Subject: CAP Modification Plan Addendum for the Former Pacific Electric Motors Site, 1009 66th Avenue, Oakland, California (Fuel Leak Case Number RO0000411)

Cap Modification Plan Addendum

Former Pacific Electric Motors Facility, 1009 66th
Avenue, Oakland, California
(Fuel Leak Case Number RO0000411)

December 4, 2014

FIGURE
3

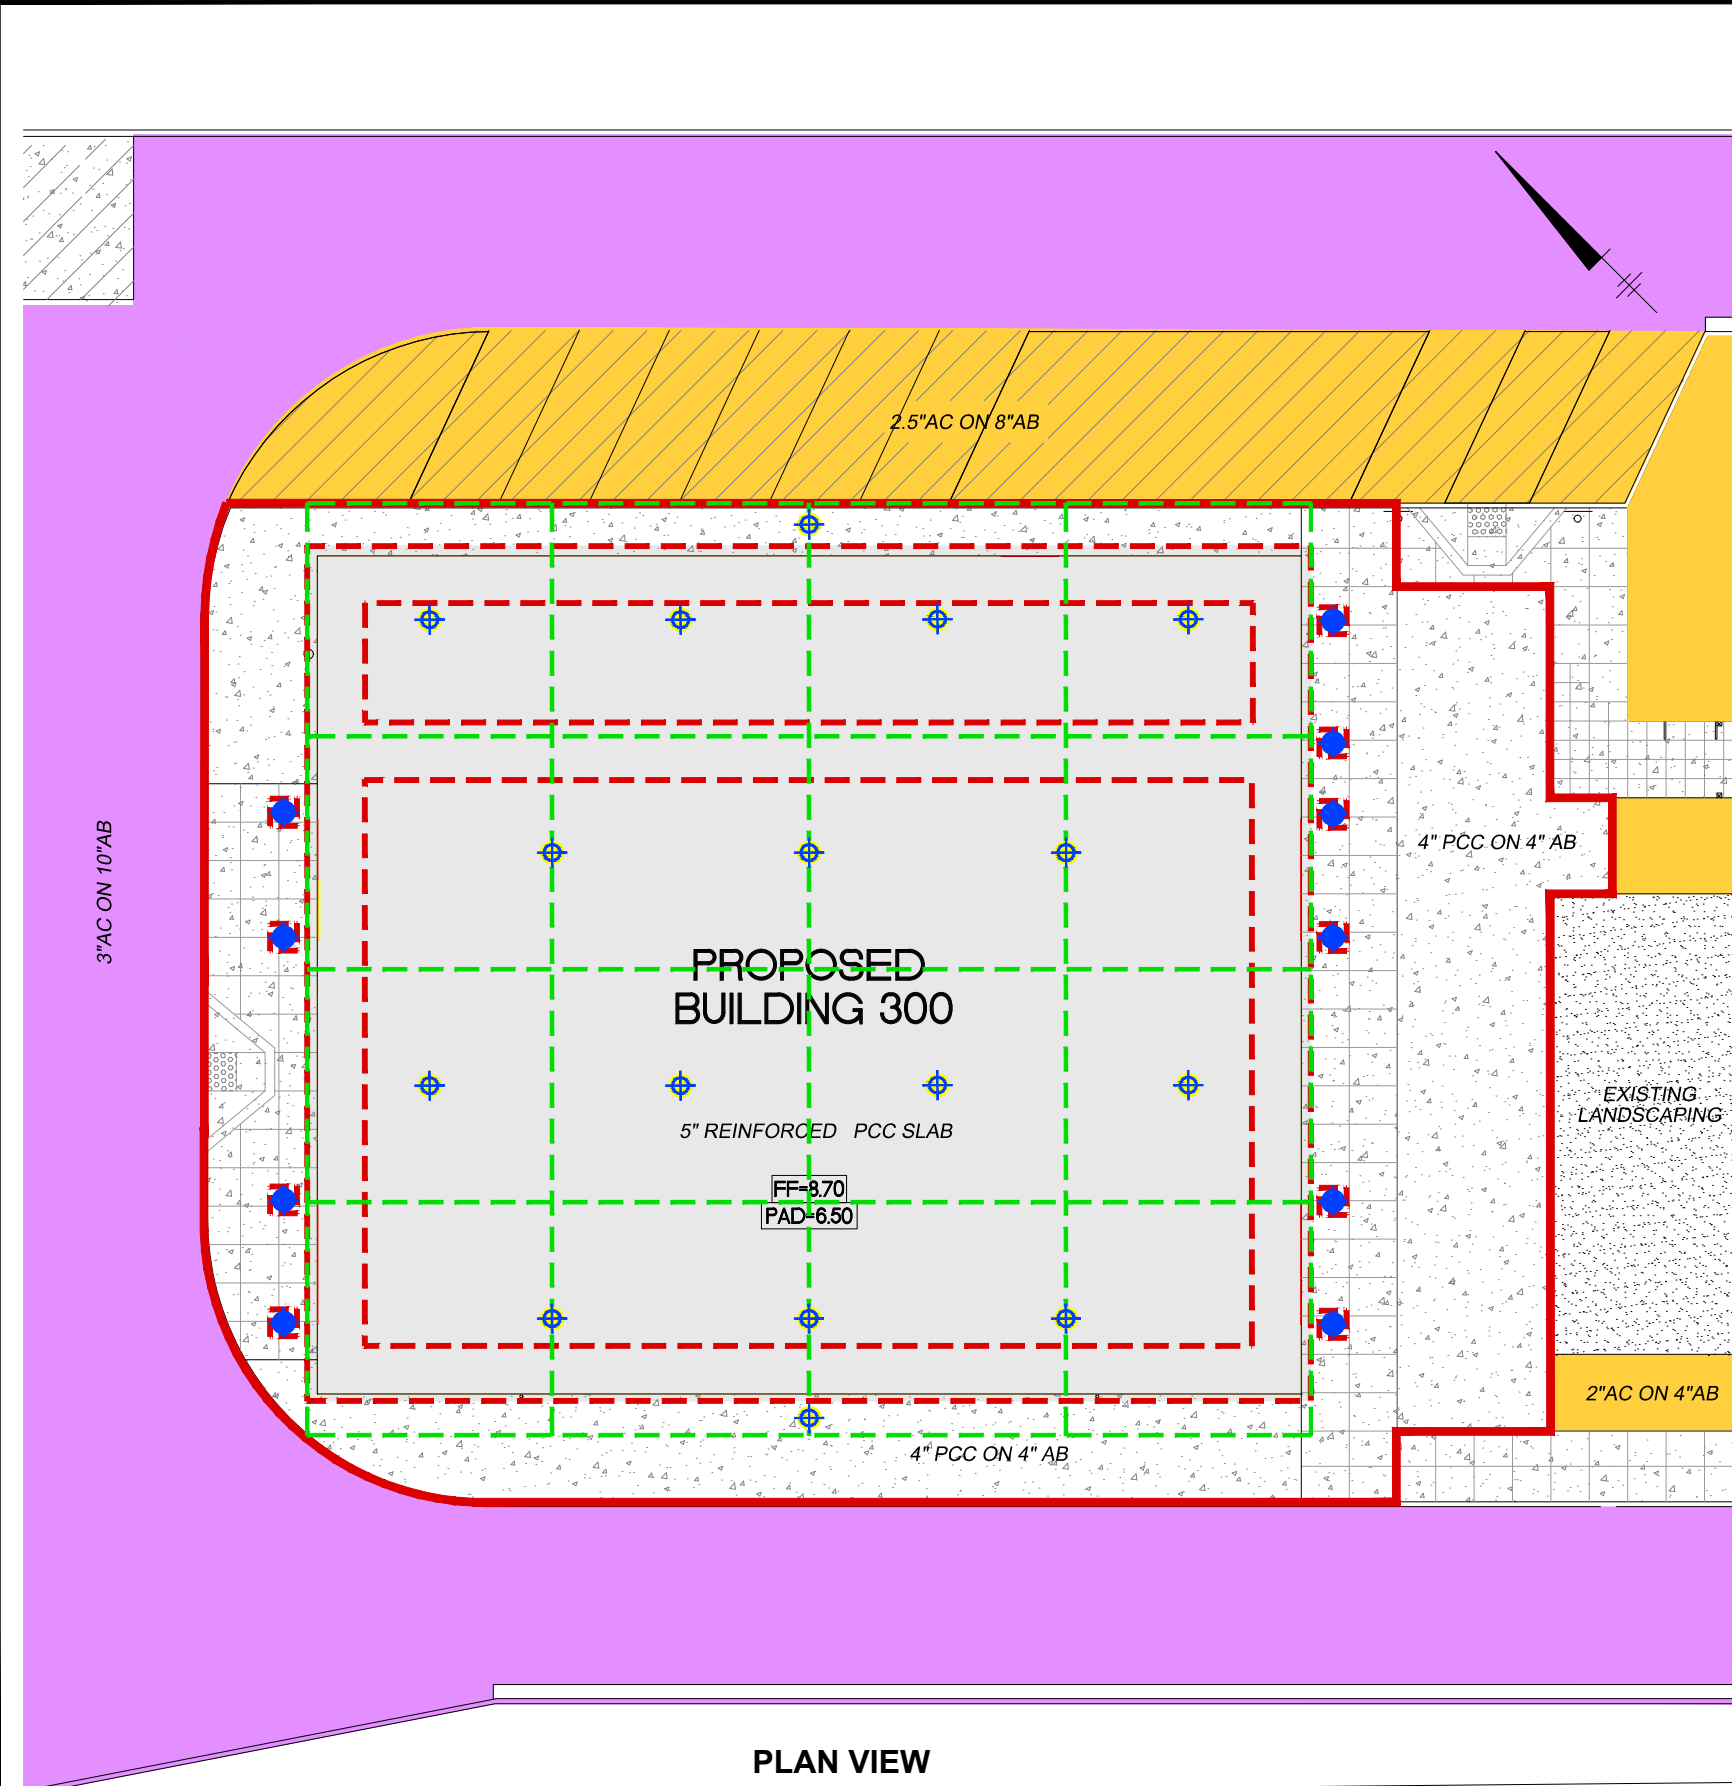
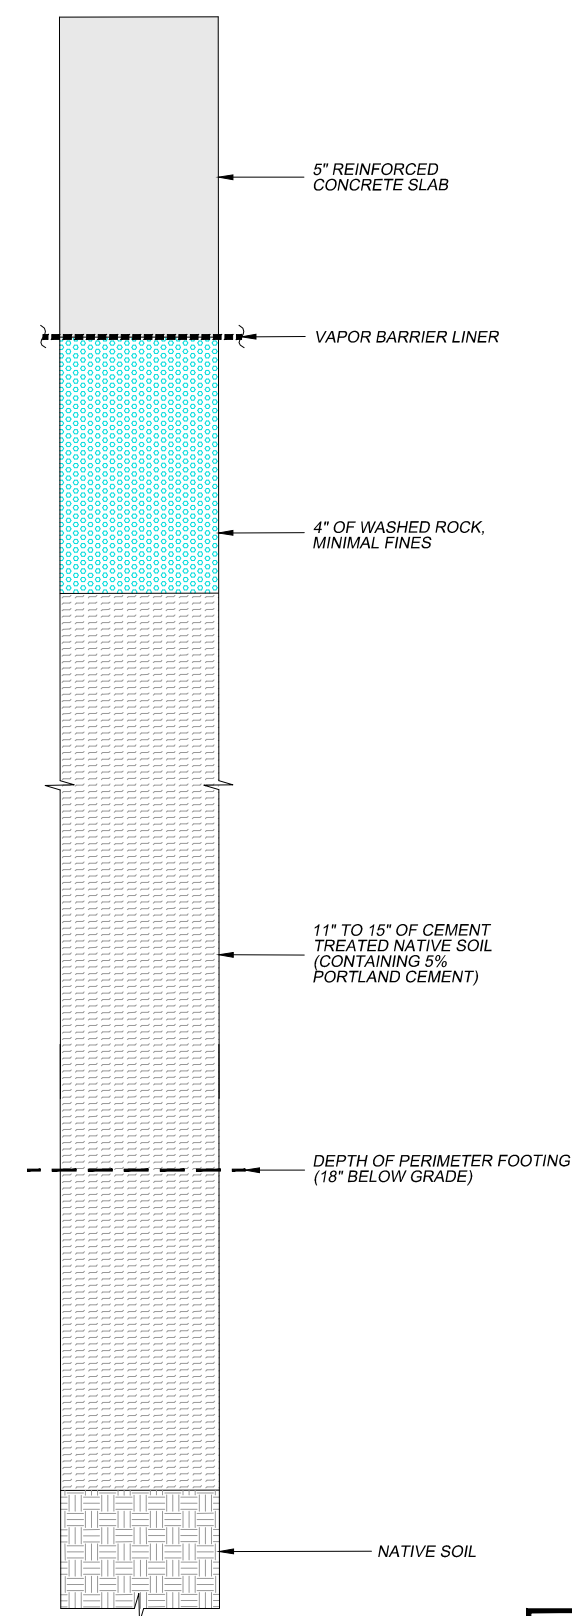
- Fourteen additional soil boring locations were added to the area of the proposed building footprint (Figure 3); soil samples will be collected only from the cement-treated native soil layer.
- Soil samples will be collected only from the cement-treated native soil layer for the two sample locations outside of the proposed building footprint (Figure 3).
- Results of the pre-demolition sampling will be used to pre-characterize and profile the soil for disposal. Therefore, Section 2.5.4 of the CMP (Soil Characterization and Off-Site Reuse/Disposal) will not be implemented.
- The estimated quantities of material that will be generated during construction were reviewed and updated quantities are presented.
- A description of the perimeter air monitoring program that will be implemented during building construction based on analytical results from the soil sampling event.

ARCADIS will advance an additional fourteen soil borings to a depth of between 0.5 and 1.0 feet bgs. Soil boring locations are shown on Figure 3. The proposed locations are positioned within the proposed building footprint in a 25 feet by 25 feet hexagonal grid.

The demolition plan includes the disturbance or removal of the existing cap located at Building 300 (see Figure 3). ARCADIS conducted a review and updated the estimated quantities of cap materials that will be generated as part of the CMP. The updated table is presented below.
